CITY OF HAM LAKE PLANNING COMMISSION AGENDA MONDAY, JULY 10, 2023

1. Josh Williams, Structural Buildings, requesting Commercial Site Plan approval to construct a 9,352 square foot office/warehouse building for H&H Contracting at 15454 Central Avenue NE

Subject: H&H Contractors requesting site plan approval to build a 9,352 square foot office/warehouse building at 15454 Central Avenue NE

To: Planning Commissioners

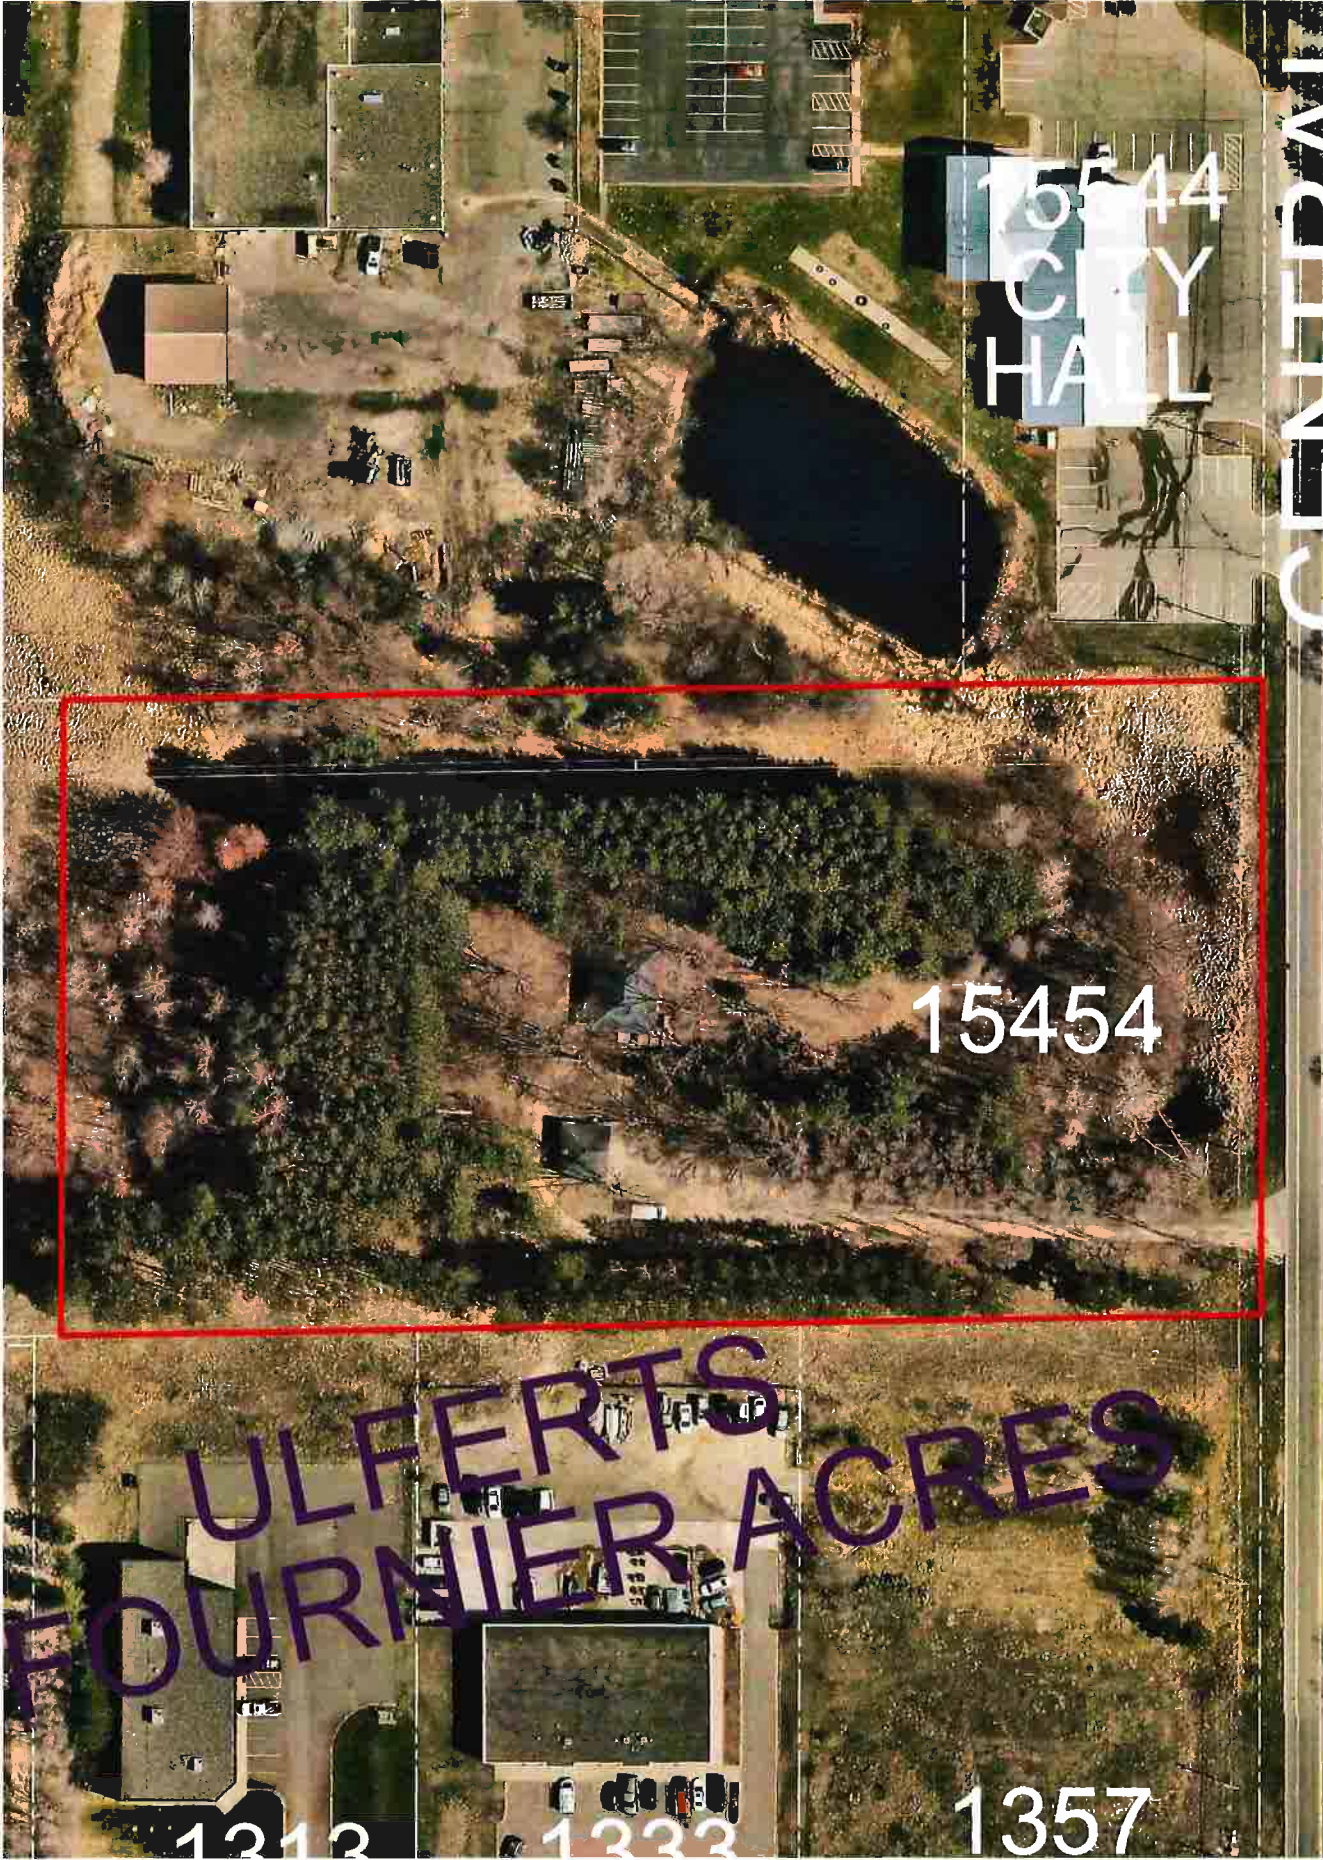
There is a drainage and utility easement over the easterly portion of the parcel which extends beyond the typical 10-foot drainage and utility easement that was obtained during the construction of the streets within Bostrom's Addition and Fredrickson Addition. An Encroachment Agreement will be required for the driveway and retaining wall encroaching into the drainage and utility easement.

There is a Rural Cooperative Power Association (RCPA) easement over the northerly 70-feet of the property as shown on the attached Site Plan and half section map. Great Rivers Energy has jurisdiction over the easement. Per the attached Great River Energy Encroachment Application, encroachments shown on the site plan within their easement are approved.

There is a Minnesota Pipeline Company easement over the southerly portion of the property ranging from 33-feet wide on the east side to 44-feet wide on the west side of the property as shown on the attached Site Plan and half section map. Koch Pipeline has jurisdiction over the easement. No work is proposed within this easement so Koch Pipeline approval is not required.

It is recommended that the H&H Contractors plans be recommended for approval, including the determination if the proposed screening is adequate.

Landscaping Plan

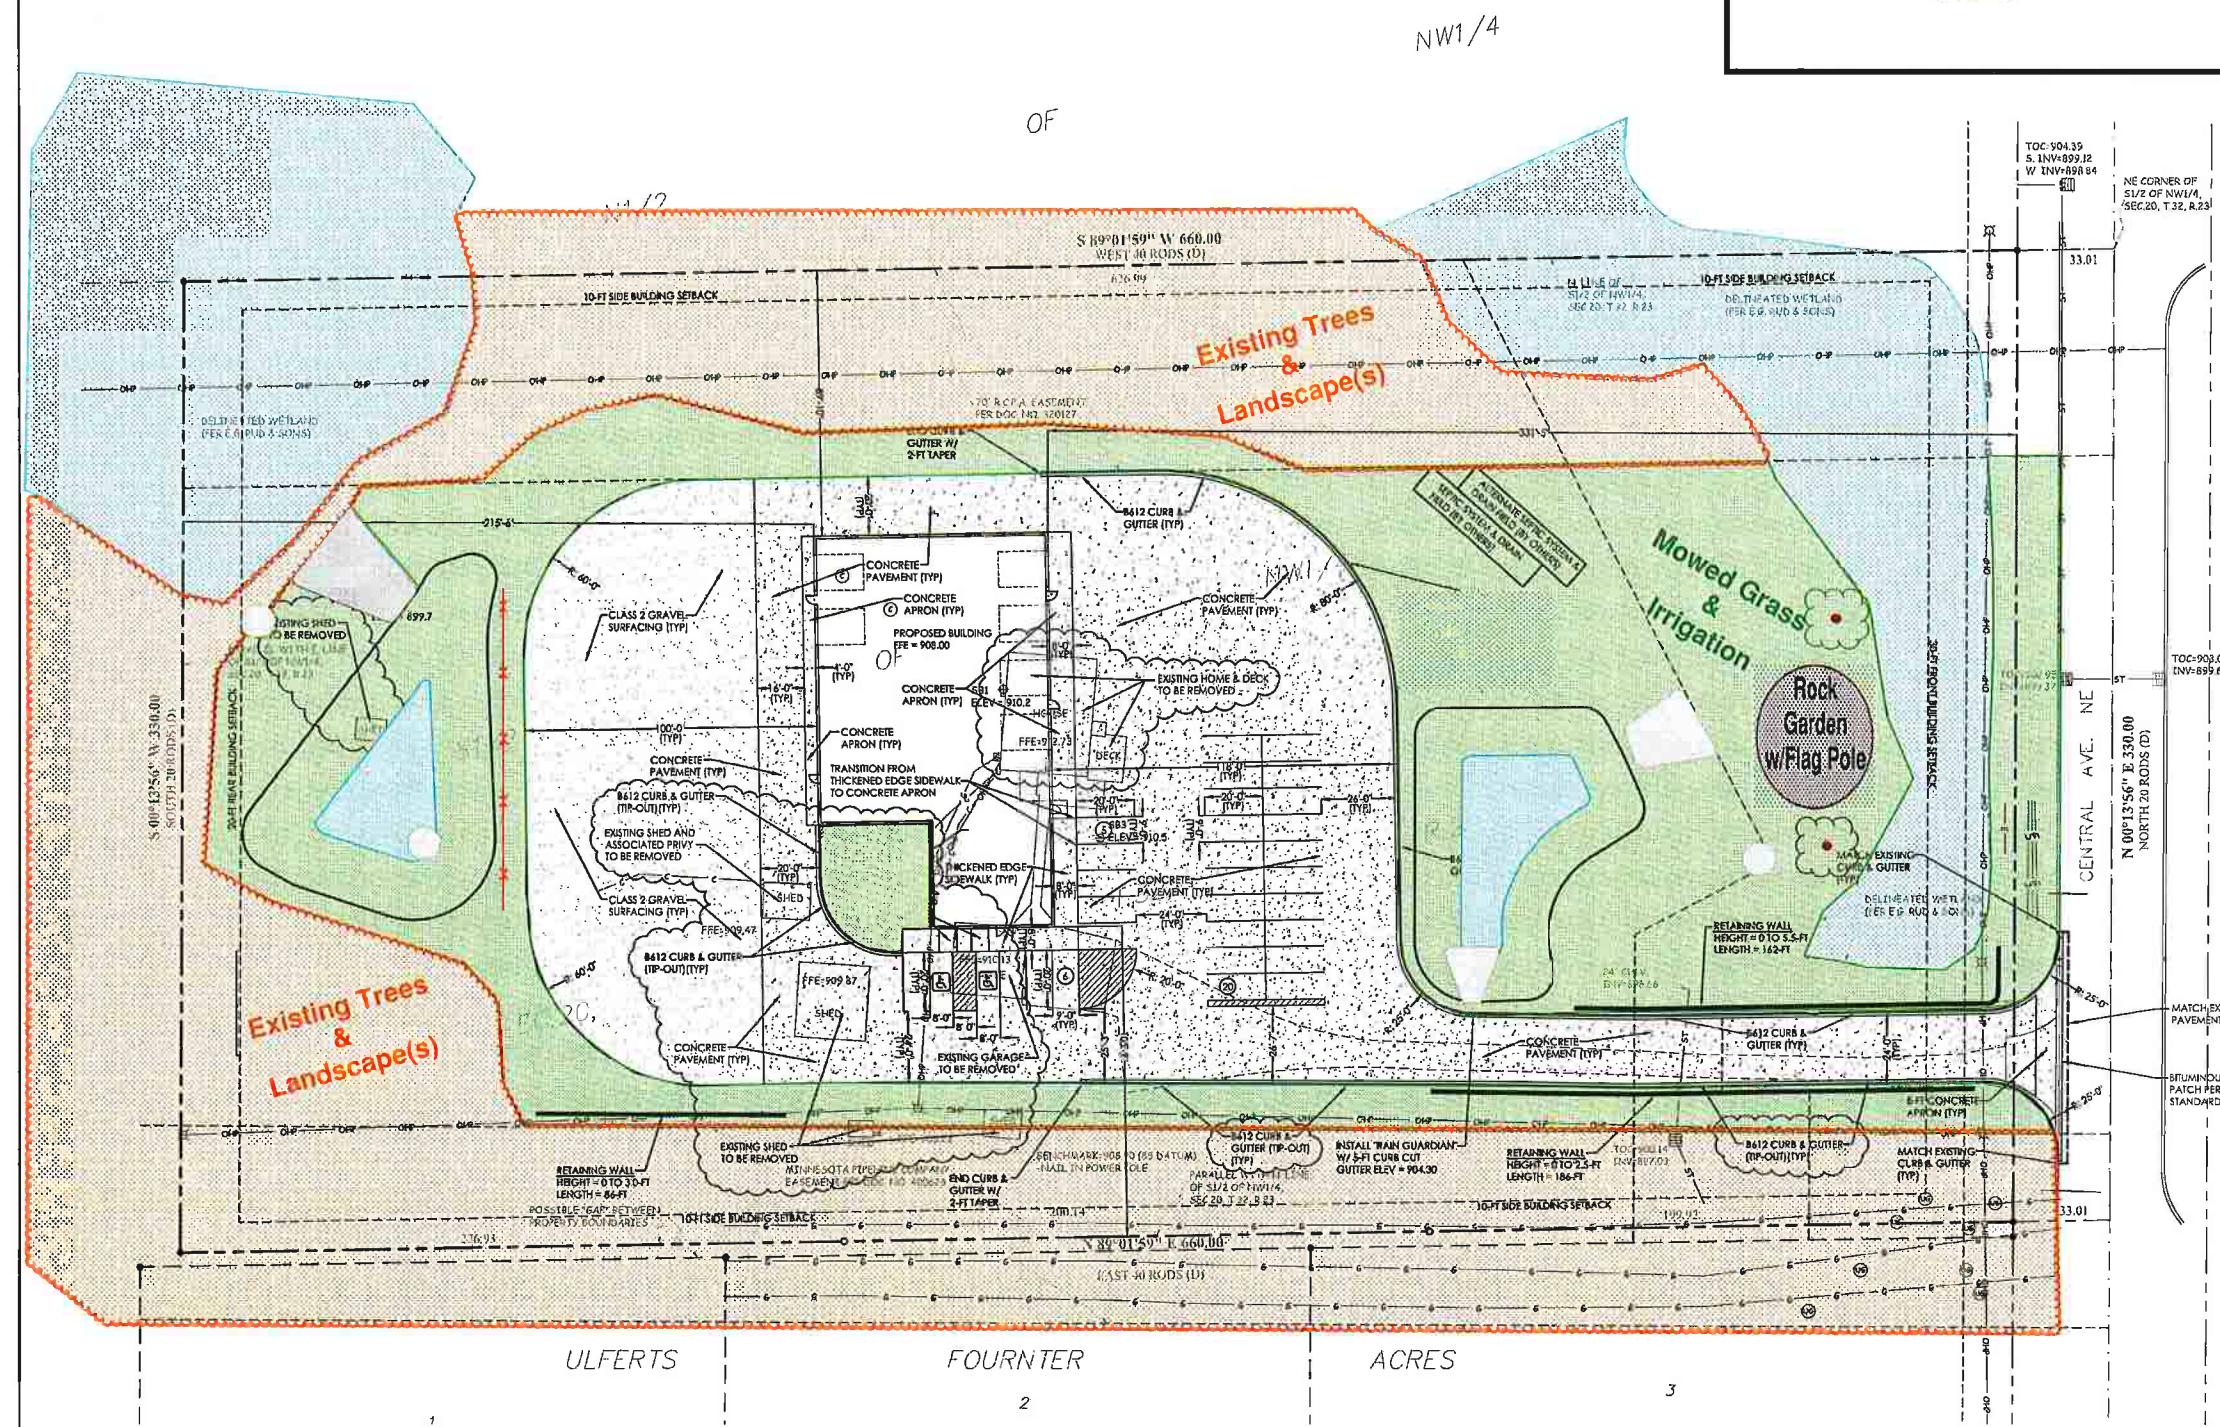
The west side of the parcel has some deciduous trees which currently provide natural screening, but may not provide proper screening during fall and winter months. Per Article 11-1853, where property lines are adjacent to residential areas, a planting screen of conifers shall be required of sufficient size and proximity to provide an intermingled screen within five years. Also, per 11-1853, decorative trees shall be planted along the right of way lines of adjacent public roadways. The Code does not require a specific number of trees along the right of way lines of adjacent public roadways. The Planning Commission will need to determine the number of trees needed to provide adequate screening along the right of way line.

The attached Landscape Plan with a revision date of June 1st shows existing tree screening to remain to the west and southwest of the proposed building. Per the zoning map, the parcels to the west are zoned Single Family Residential (R-1). Landscaping in commercially zoned areas is to be per 11-1800 of City Code (attached). The Landscape Plan also shows two existing trees to remain and a rock garden and flag pole installed along Central Avenue. Per 11-1853(B) of the City code, decorative trees shall be planted along the right of way lines of adjacent public roadways. 11-1860 allows for case-by-case evaluation for landscape approval and “strict adherence to the remaining provisions of Article 11-1800 may be unnecessary where size, spatial relationships, topography or other physical features render a given landscaping plan aesthetically acceptable, and departures from the strict observance of the elements of Article 11-1800 shall not be considered variances requiring a showing of physical hardship. Conversely, an applicant shall be expected to meet the general spirit of this article in establishing an aesthetically pleasing landscaping plan”. A determination needs to be made as to whether the proposed Landscaping is adequate where adjacent to R-1 zoning and the City Right-of-Way or if additional screening is required.

Boulder Wall to be made from 3' boulders.
Base course will be 20' in diameter.
2nd Tier to be 6' inset from outer ring of base course.
3-6" River Rock w/Annabelle Hydrangeas
Standard allowable size flag pole w/3x5 Post Flag.

Alternate for Screening:
8' Wooden Fence or Cambrourous Trees
TAB: Evaluated by Building Official
before Certificate of occupancy.
